Re: ***Additional Site Assessment Work Plan***
76 Service Station # 1028 RO # 02967
5300 Broadway
Oakland, CA

**RE: Soil and Water Investigation
Work Plan Addendum
Fuel Leak Case No. R000002967
Geotracker Global ID T0619732490
Unocal#1028 / ConocoPhillips # 251028
5300 Broadway
Oakland, CA 94618**

On behalf of Conoco Phillips Company (COP), Delta Consultants (Delta), has prepared this *Soil and Water Investigation Work Plan Addendum* ("Work Plan Addendum") as directed by the Alameda County Environmental Health (ACEH) in the letter dated March 6, 2009.

FIGURE 1
PROPOSED SOIL BORING LOCATIONS
CONOCOPHILLIPS SITE NO. 251028
5300 BROADWAY
OAKLAND, CALIFORNIA

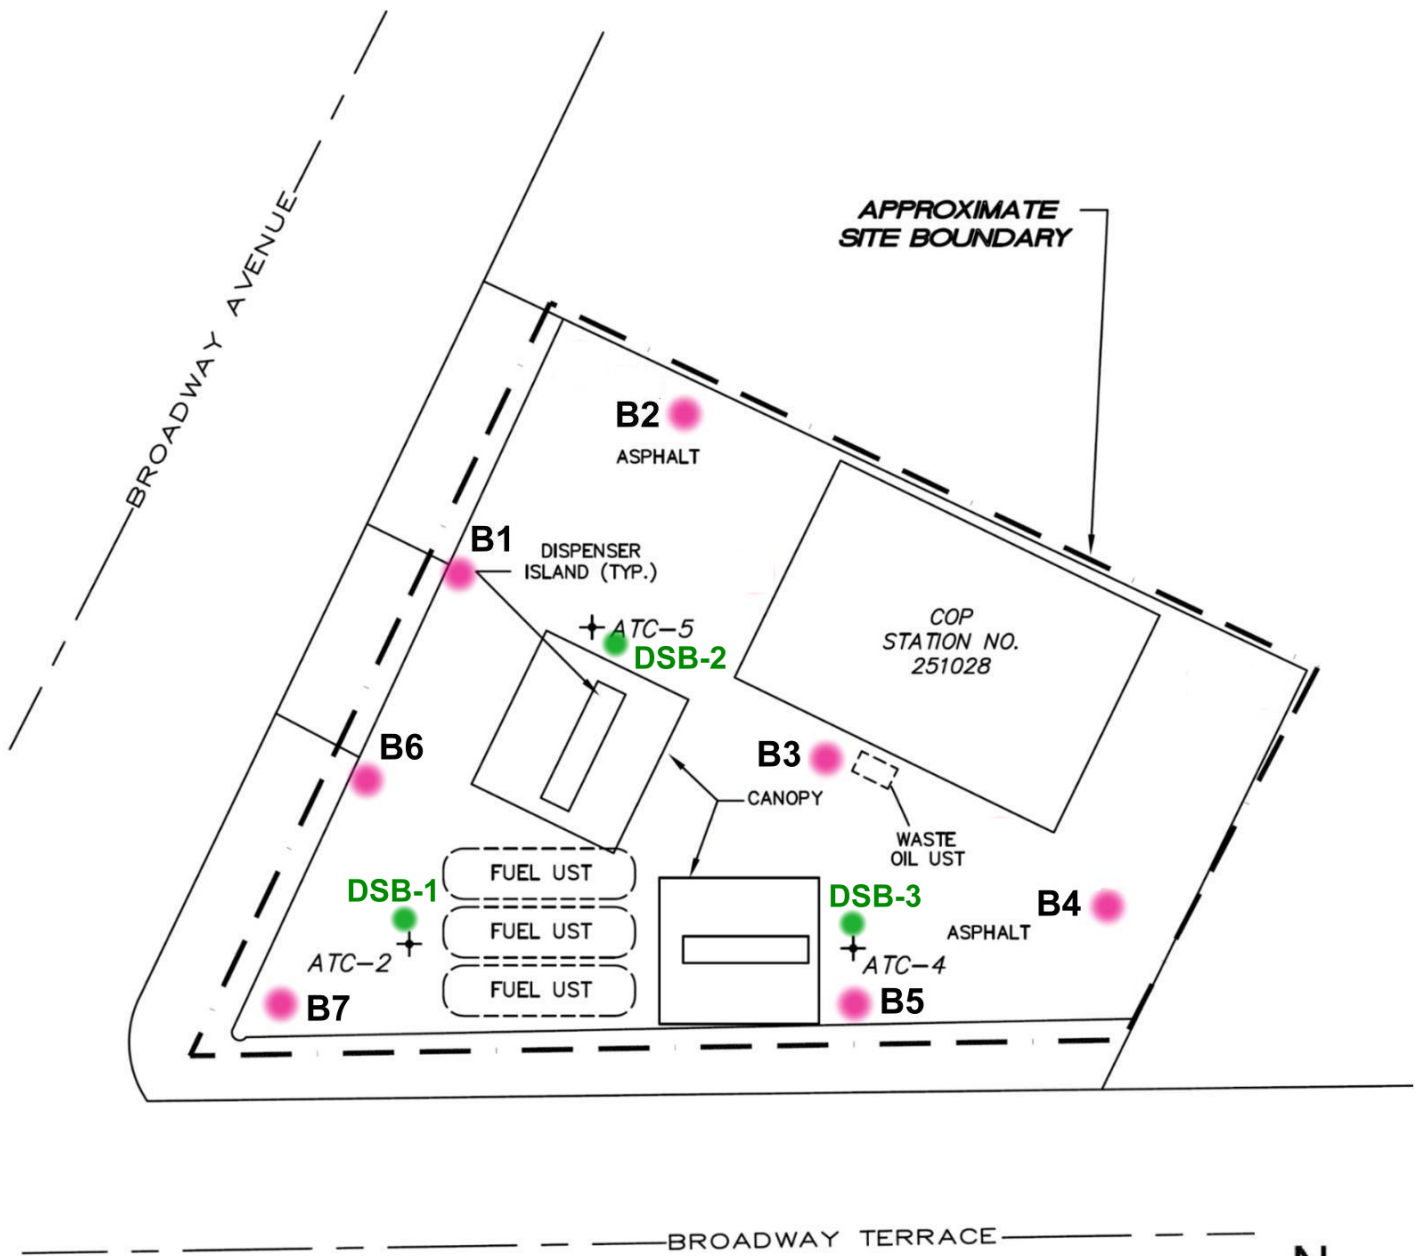
- 1. "Vertical Extent of Contamination. Your work plan does not include evaluation of the vertical extent of contamination at the site as requested in the ACEH letter dated June 26, 2008 but suggests that this will be defined in the second phase of the work. Following the Expedited Site Assessment Process, ACEH recommends that the vertical extent of contamination be assessed along with the lateral extent of contamination. Please update your work plan to assess this data gap."**

- 4. "Preferential Pathway Survey - The results of the utility survey indicate that utilities can be a preferential pathway for contaminants at the site. If your borings results indicate that contamination is present along the Broadway Terrace side of the site (proposed borings B1, B6 and/or B7), please include your proposal to investigate potential migration along the utilities in the report requested below."**

To evaluate of the vertical extent of contamination at the site, as requested by ACEH, three (3) deep soil borings designated DSB-1, DSB-2, and DSB-3 are proposed to be drilled to approximately fifty (50) ft bgs using rotary drilling at those locations shown on Figure 1, attached. The three deep soil borings are proposed to be located in the close proximity of ATC-2, ATC-2, and ATC-4 where higher levels of contaminants have been detected in 2007 in soil/groundwater (near the "source"). Because refusal was encountered during previous drilling (geoprobe) activities, all three deep soil borings will be advanced using a truck mounted drill-rig equipped with 8-inch diameter hollow stem augers.

As noted by ACEH, if contamination is detected in B1, B6, and B7, potential migration of contaminants exist along the preferential pathways created by the existing utilities; therefore, based on this first phase results, conclusions, and recommendations, and if warranted, additional soil/groundwater sampling will be proposed along these preferential pathways.
